ADDENDUM #1 - 6/24/2025
1. REVISED SHEETS: D-1, D-2, D-6, D-7, INT-2, INT-3, INT-7, P-1, P-2, P-4, P-6, U-1 - U-7, U-12, W-1, W-2, W-5 - W-7, E-1 - E-9, PM-8, X-15, AND X-16.

E. MAIN STREET & S. HANCOCK STREET
ASSESSMENT DISTRICT - 2025

CITY PROJECT NO. 15125
CONTRACT NO. 8784

15125
D-7

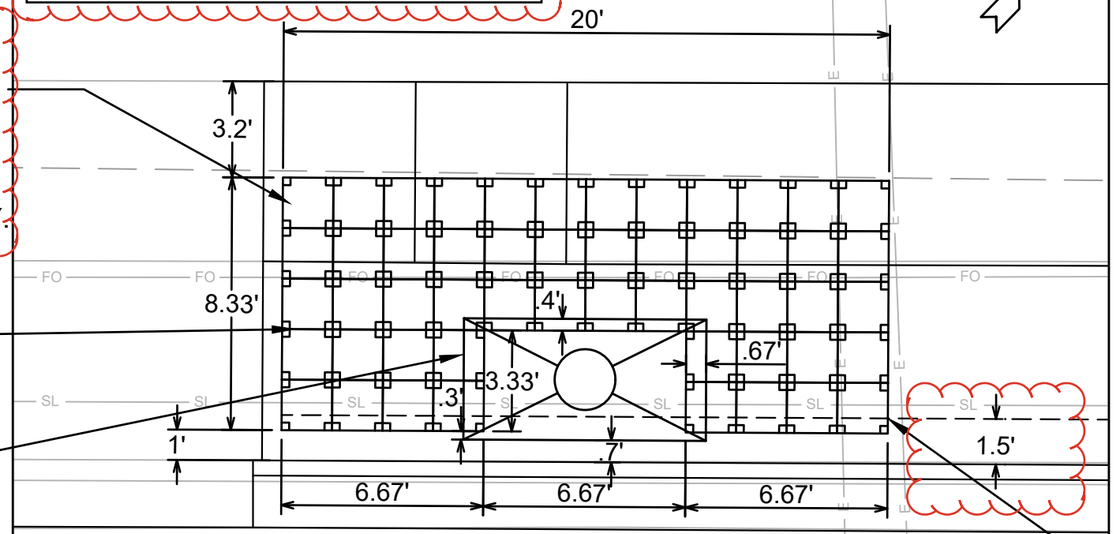
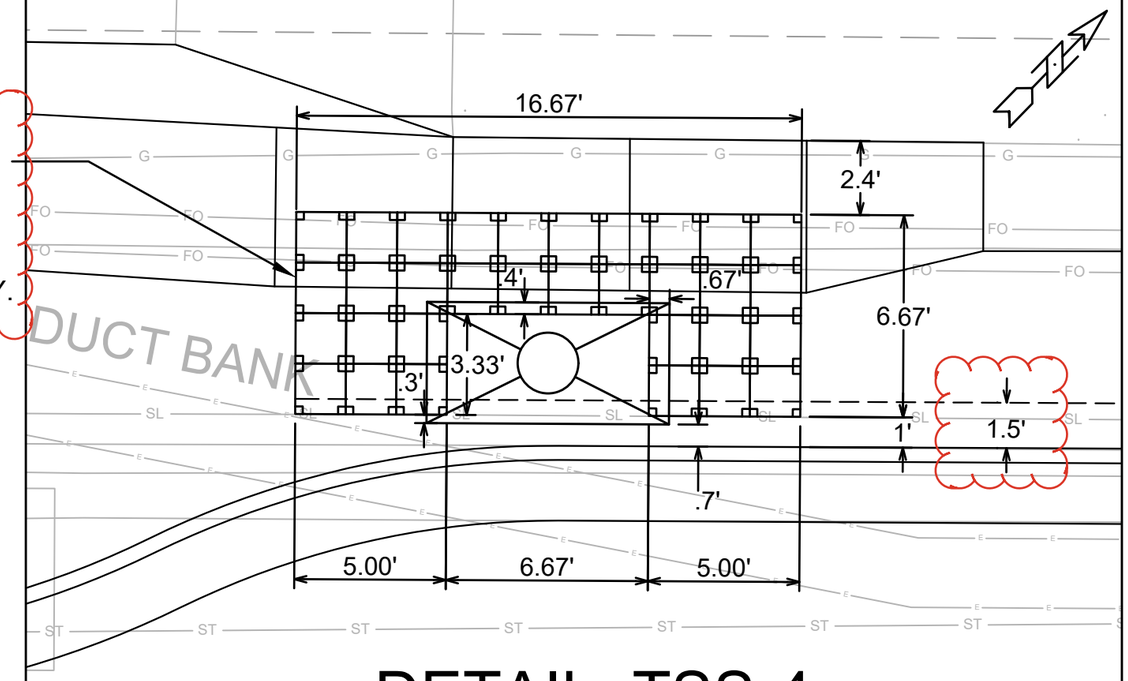
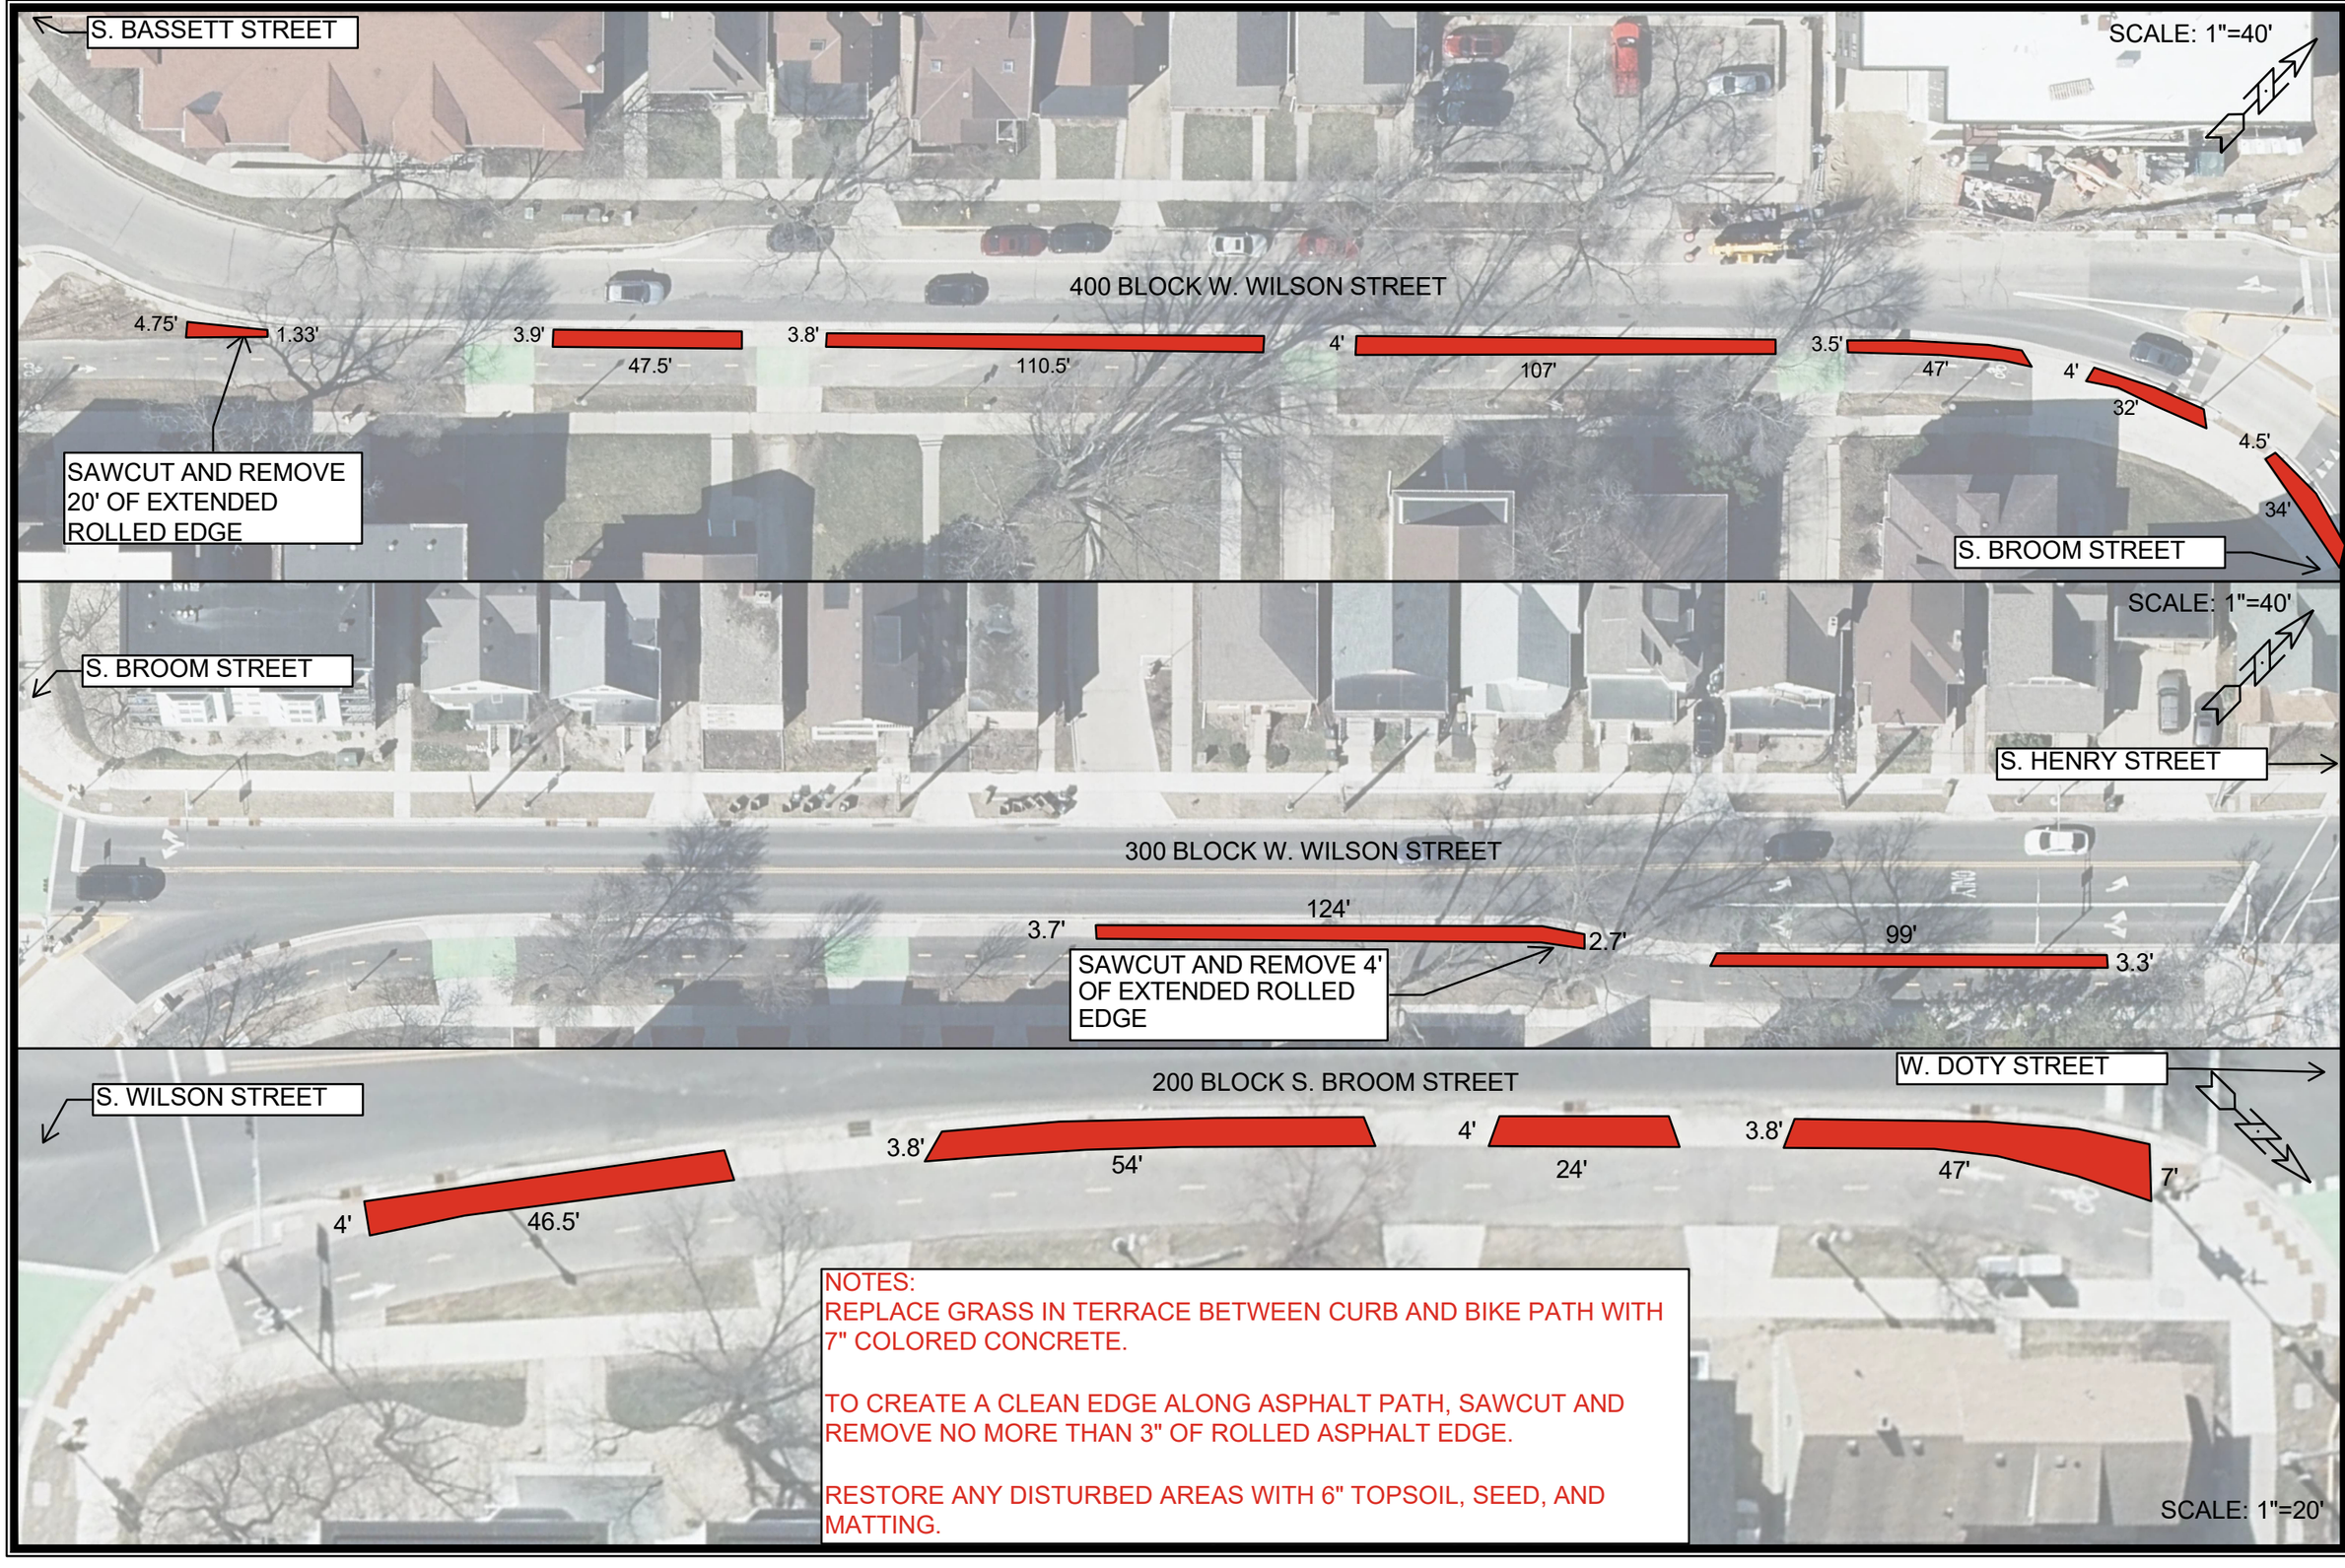
ADDENDUM #1 - 6/24/2025
1. REVISED CALCULATIONS FOR TERRACE SUPPORT SYSTEMS AND PLANTING MIX TOPSOIL.
2. ADDED UNDERDRAIN FOR TSS-2, TSS-3, AND TSS-4.

15125
W-6

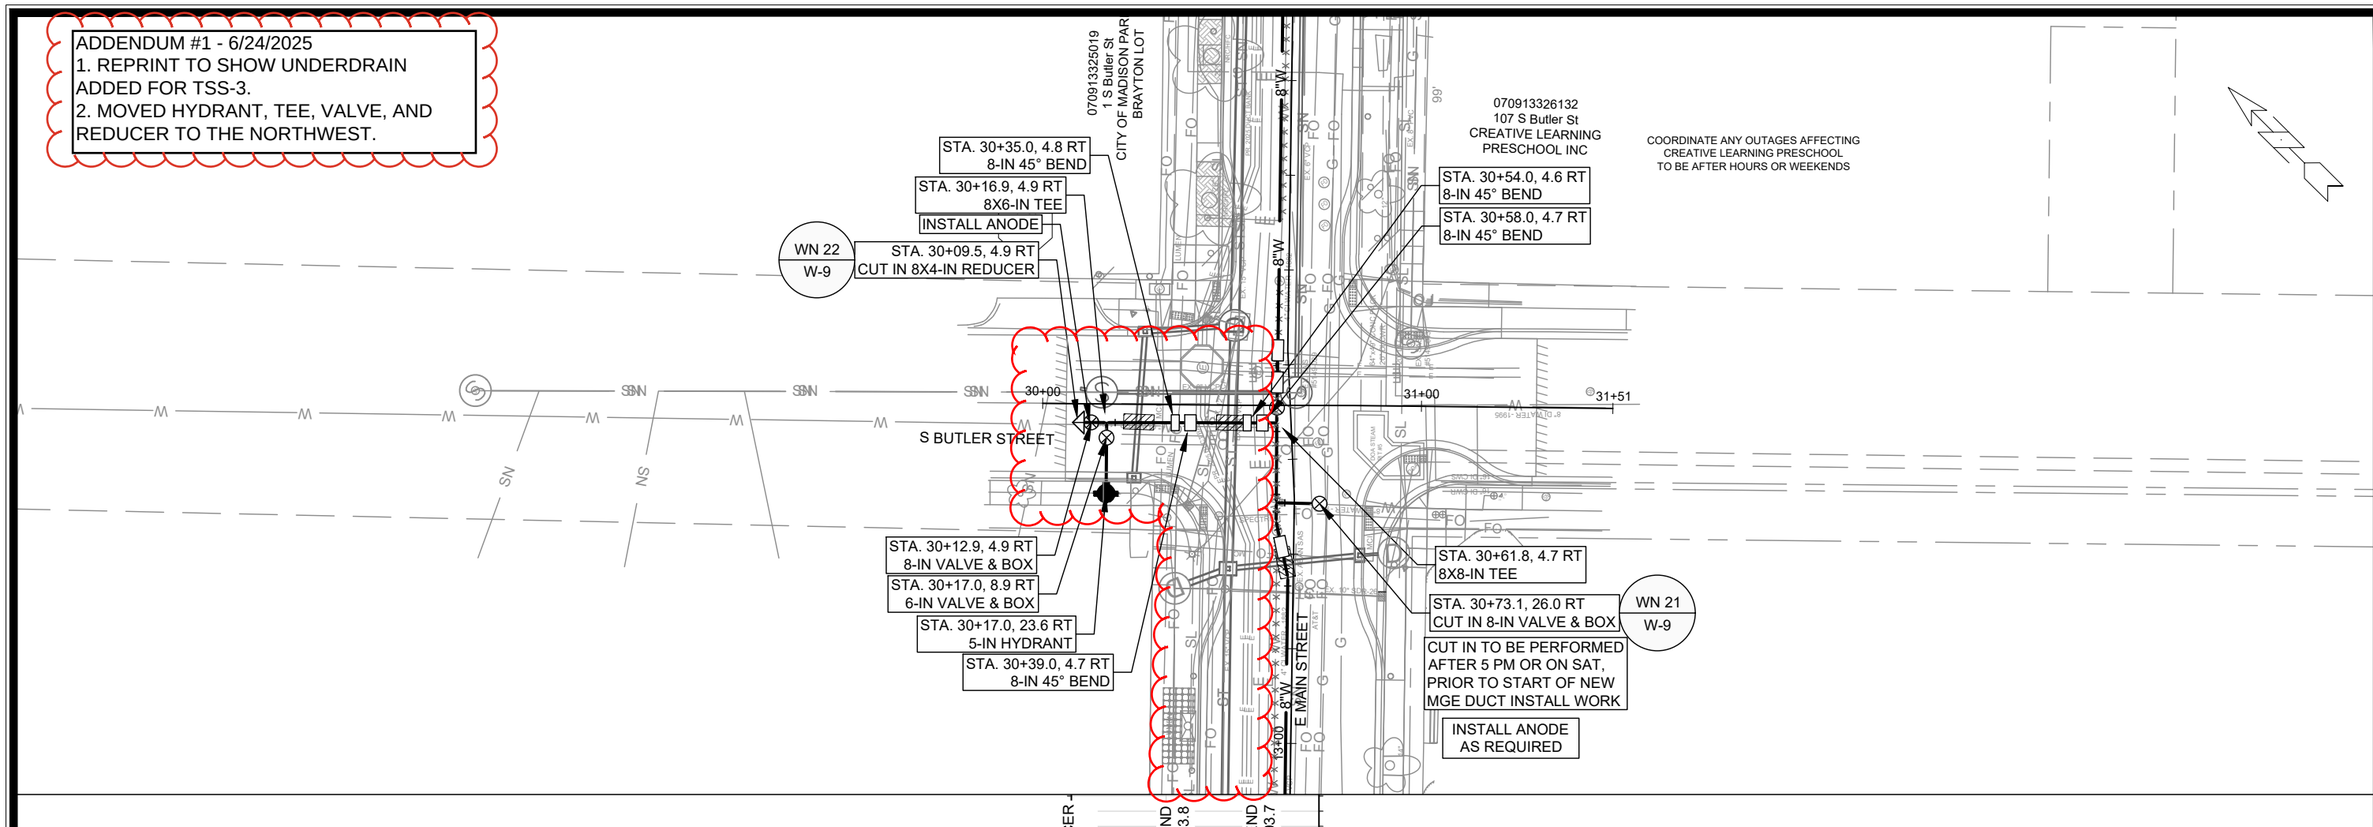
ADDENDUM #1 - 6/24/2025
REPRINT TO SHOW ADDITIONAL CURB REMOVAL/ REPLACEMENT ON S. HANCOCK STREET SOUTH OF E. WILSON STREET.

Designed By: ---
Date: 6/16/2025 8:35 AM
Scale: ##########
W-7

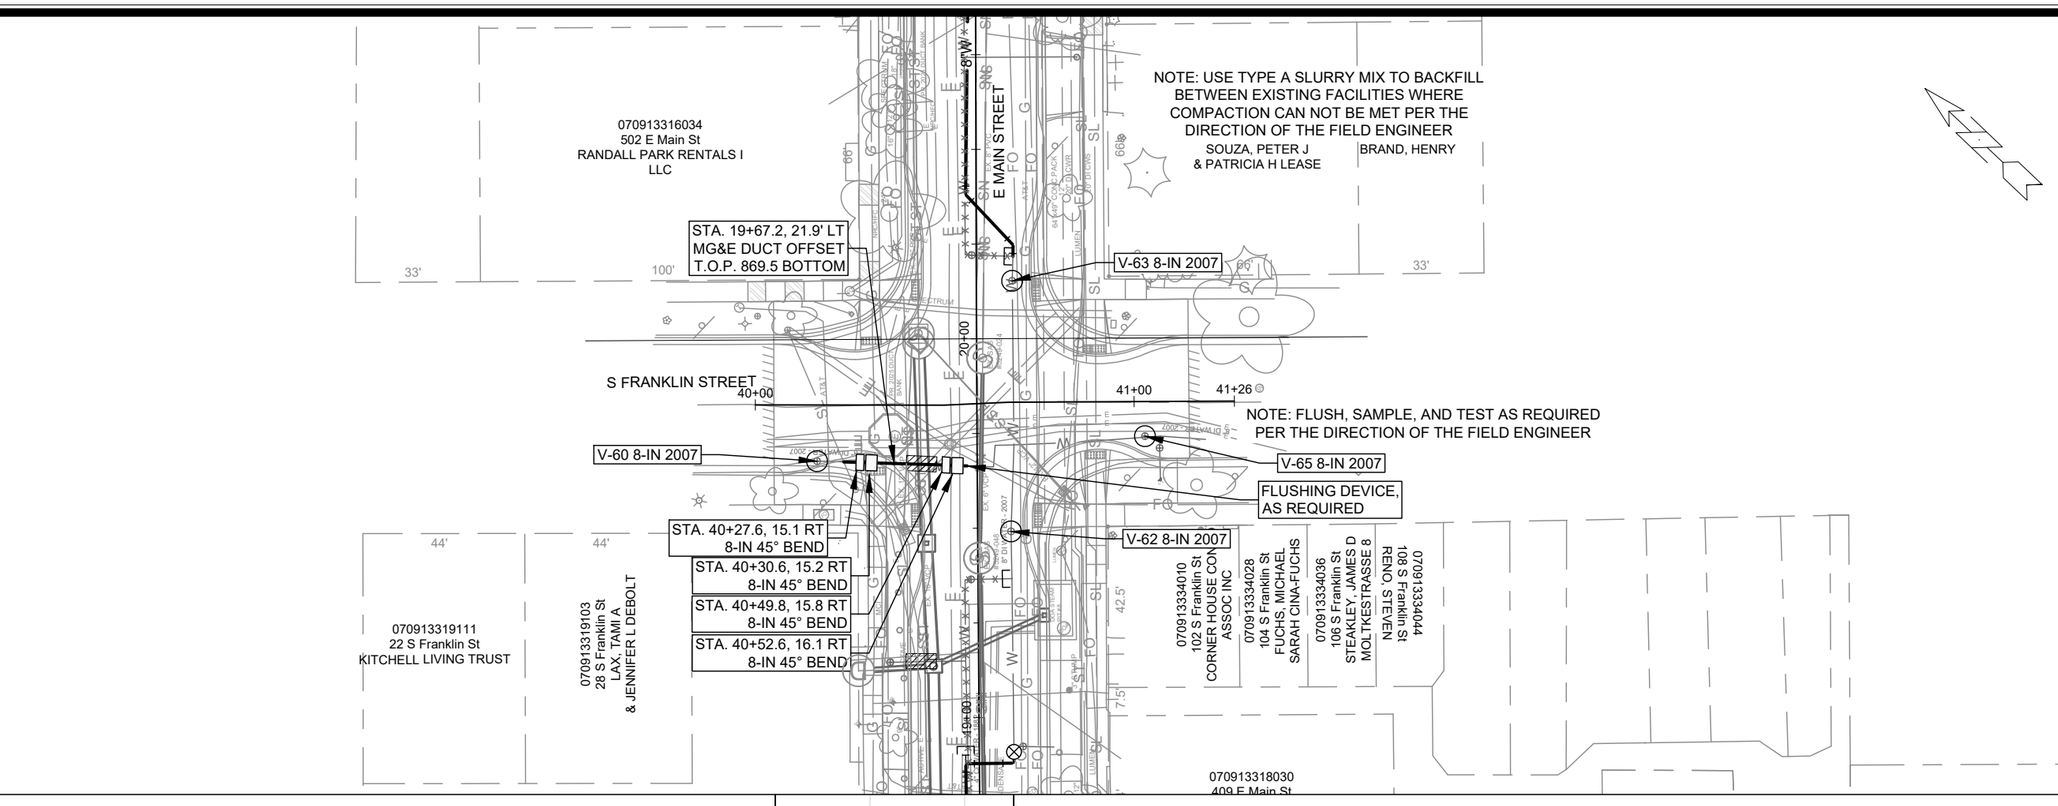
ADDENDUM #1 - 6/24/2025
1. REPRINT TO SHOW UNDERDRAIN ADDED FOR TSS-3.
2. MOVED HYDRANT, TEE, VALVE, AND REDUCER TO THE NORTHWEST.

15125
PM-8

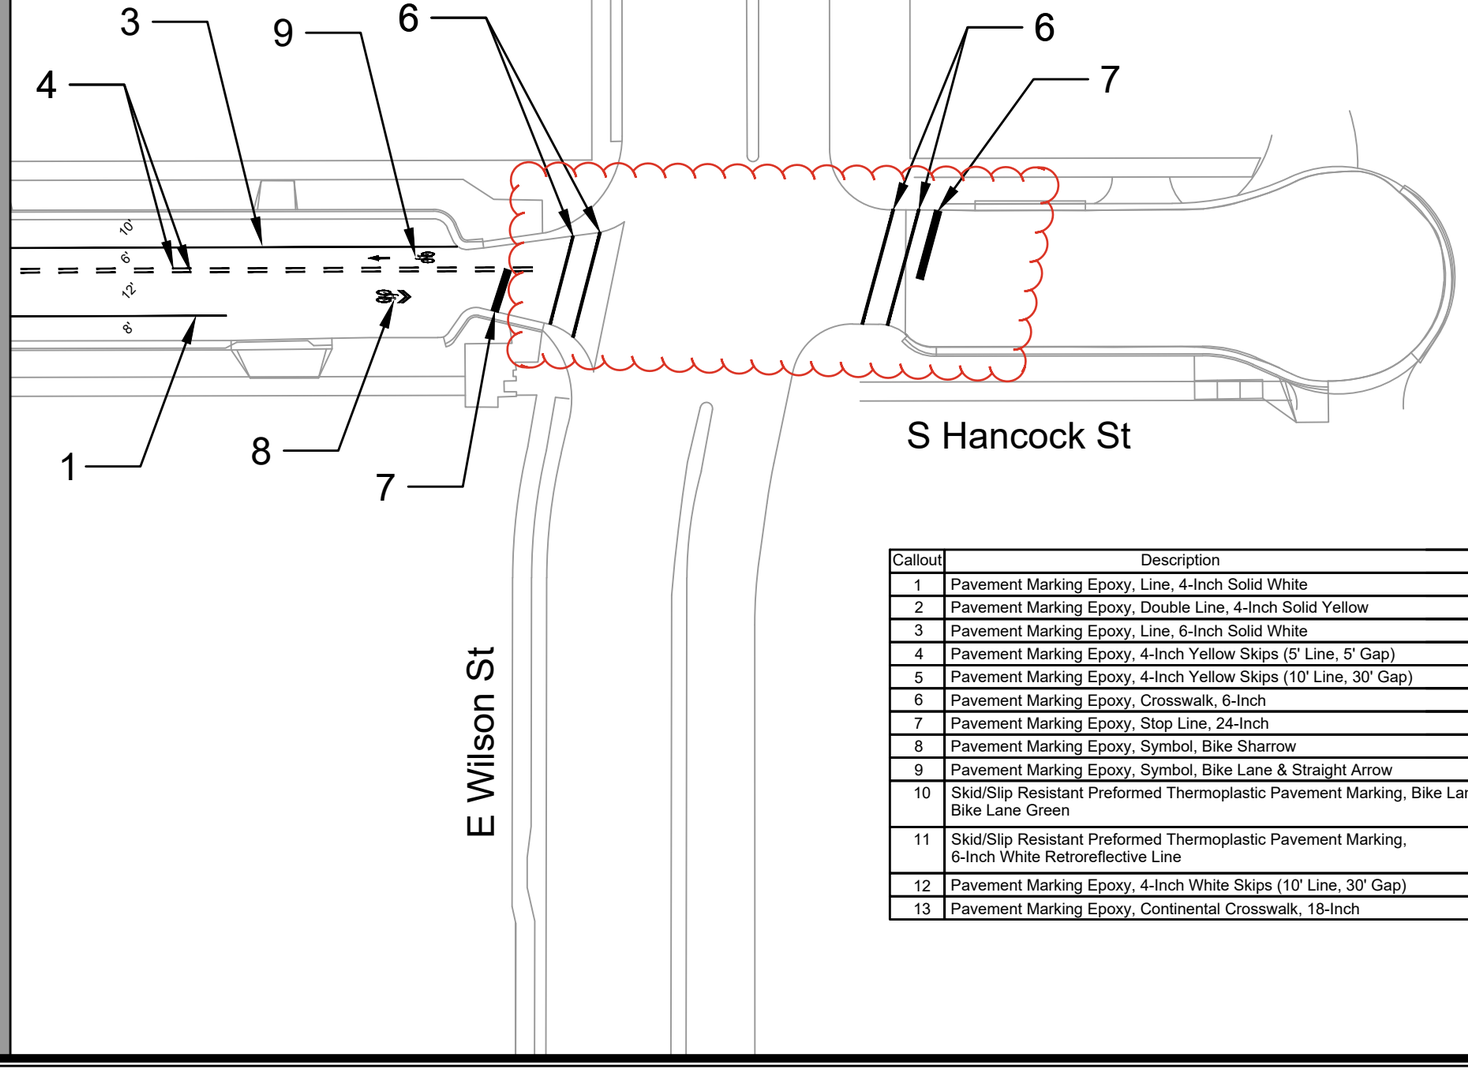
ADDENDUM 1 - 6/24/2025
1. INCREASED CURB REMOVAL/REPLACEMENT ON SOUTHWEST SIDE OF S. HANCOCK STREET.
2. ADJUSTED CROSSWALK MARKINGS TO MATCH EXISTING GEOMETRY.
